**1958 Agreement: Consideration of draft amendments
to existing Regulations submitted by GRB****Proposal for Supplement 2 to the 03 series of amendments to
Regulation No. 51 (Noise of M and N categories of vehicles)****Submitted by the Working Party on Noise***

Supplement 2 to the 03 series of amendments to Regulation No. 51 (Noise of M and N categories of vehicles)

Annex 7, amend to read:

Figure 1
Flowchart for the assessment concept for ASEP according to Annex 7

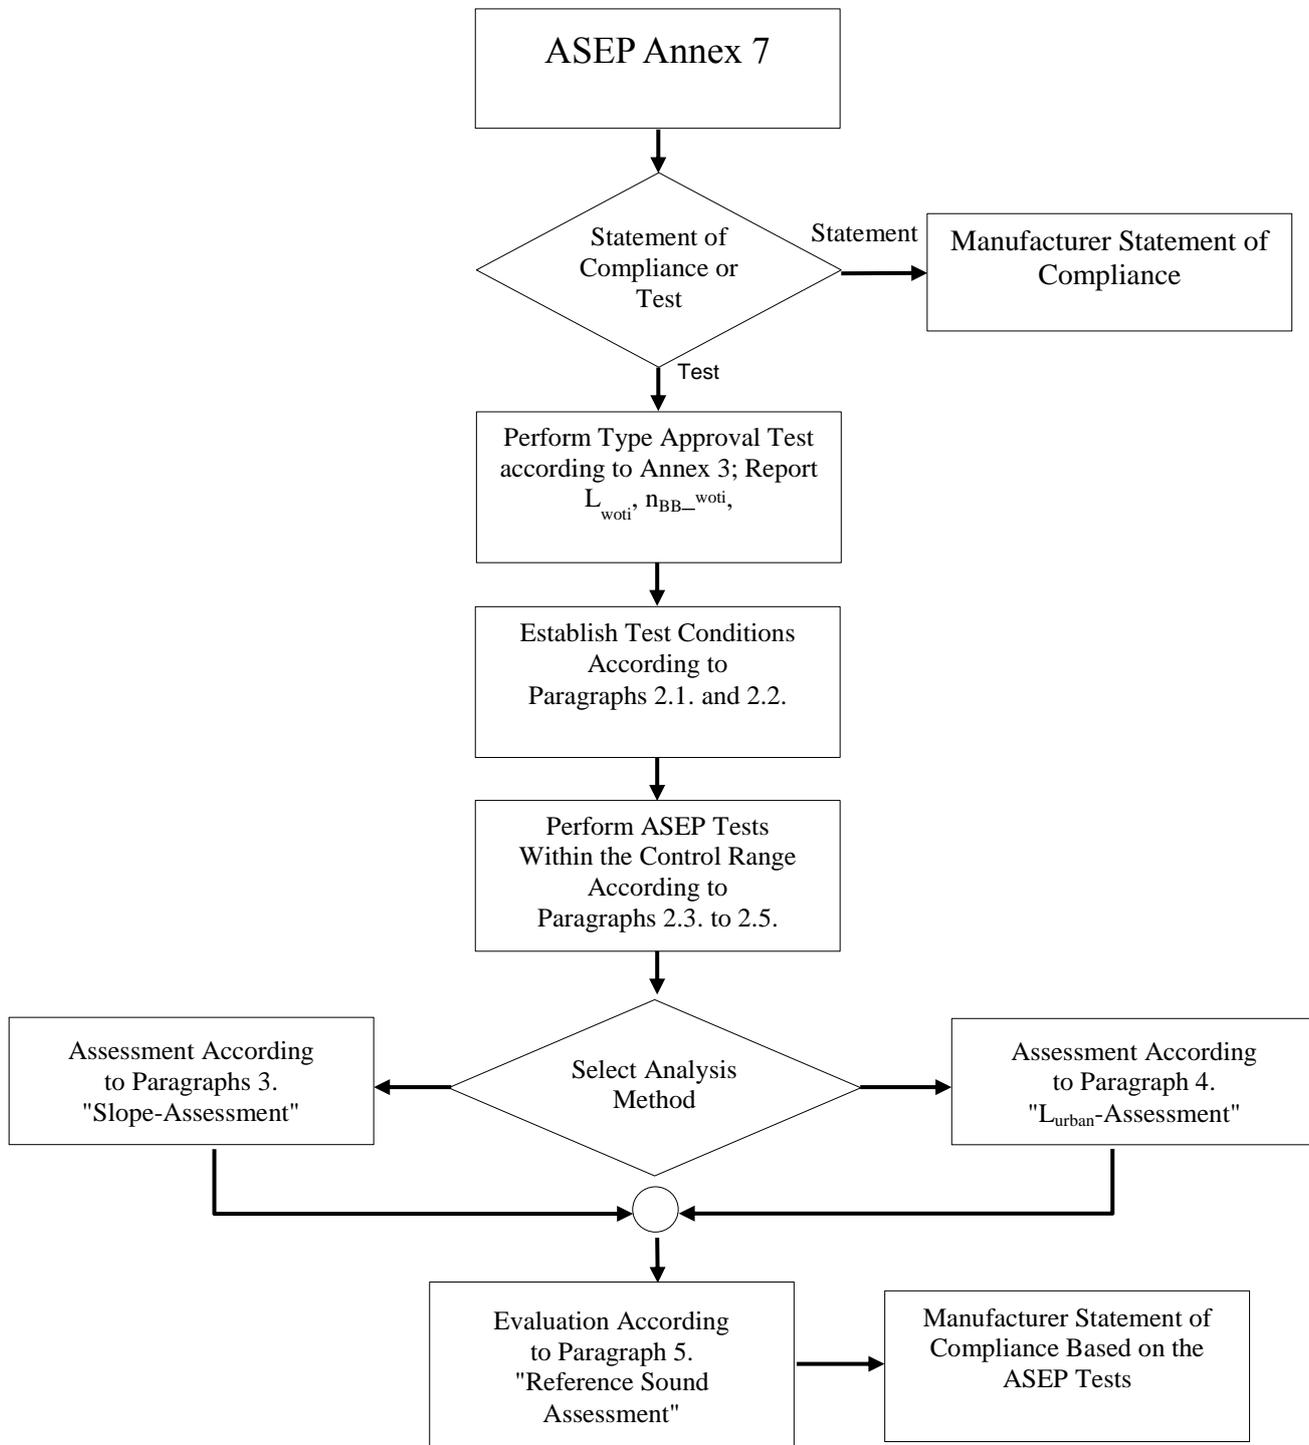
1. General (see the flowchart in Appendix 2, Figure 1)

Figure 2
Flowchart for the vehicle sound assessment according to Annex 7, paragraph 5. "Reference sound assessment"

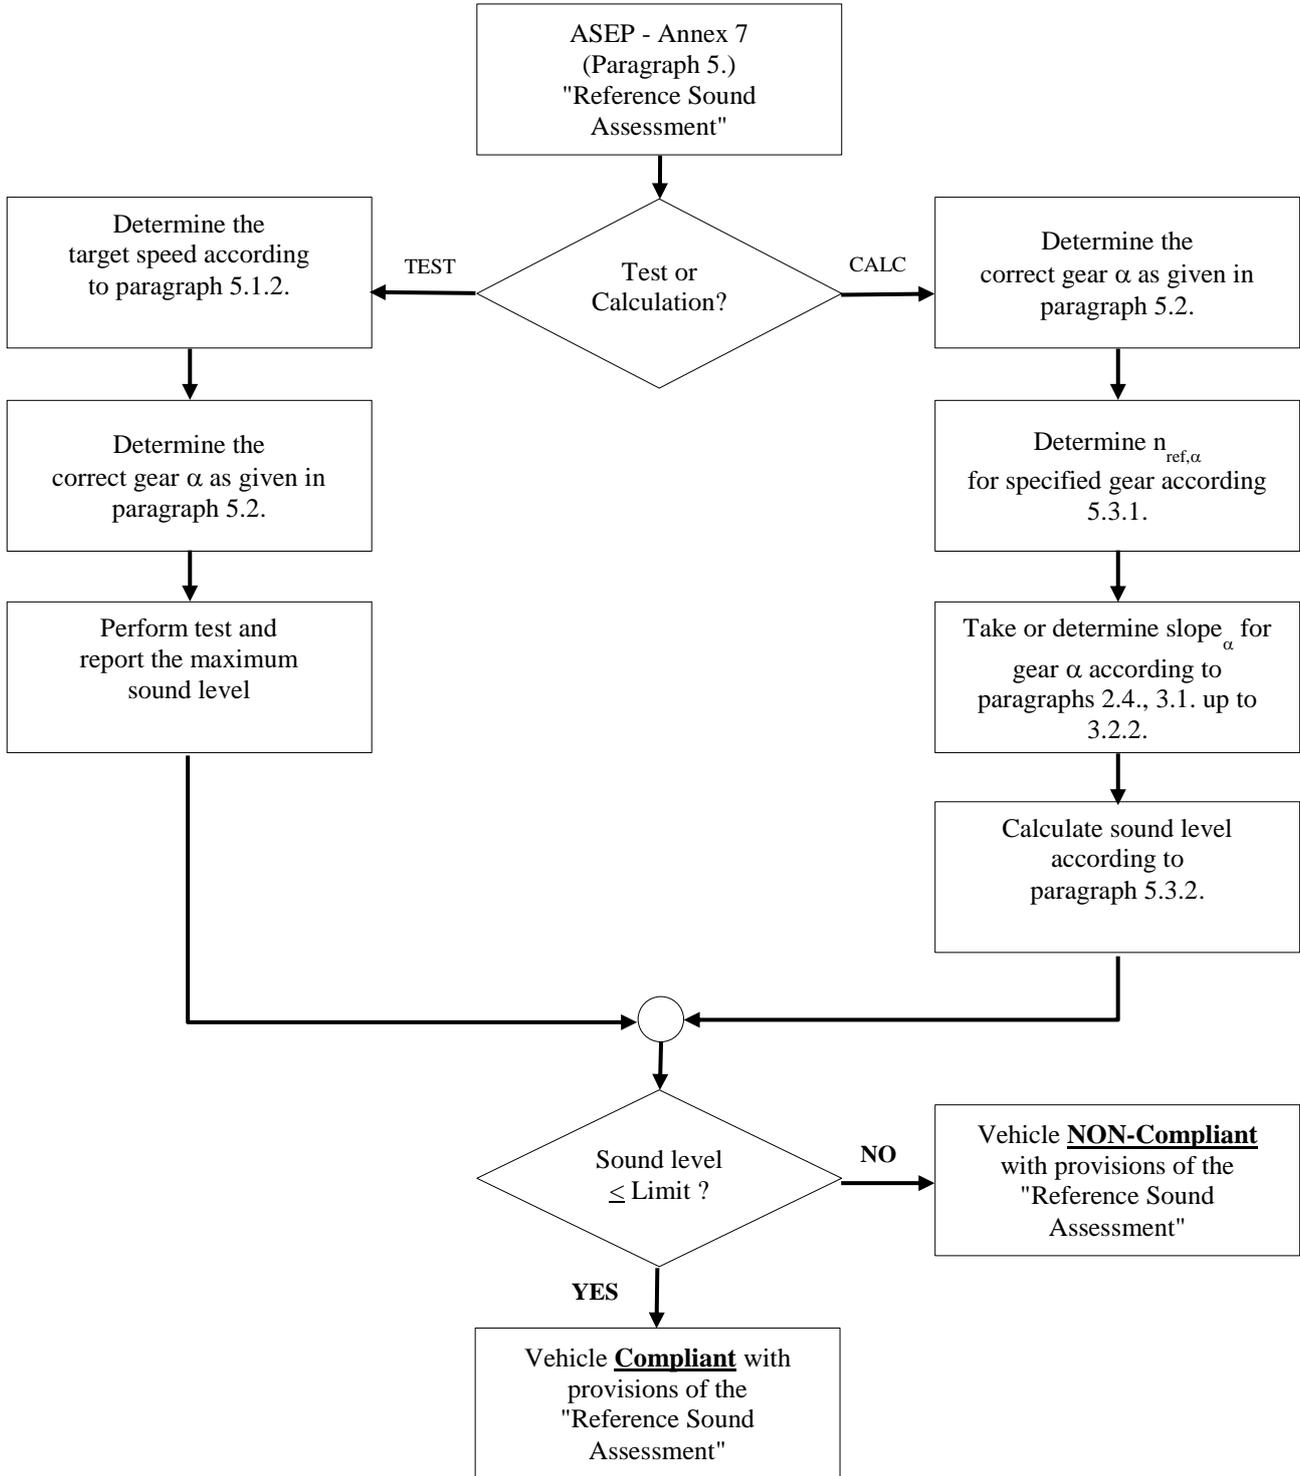
5. Reference sound assessment (see the flowchart in Appendix 2, Figure 2)
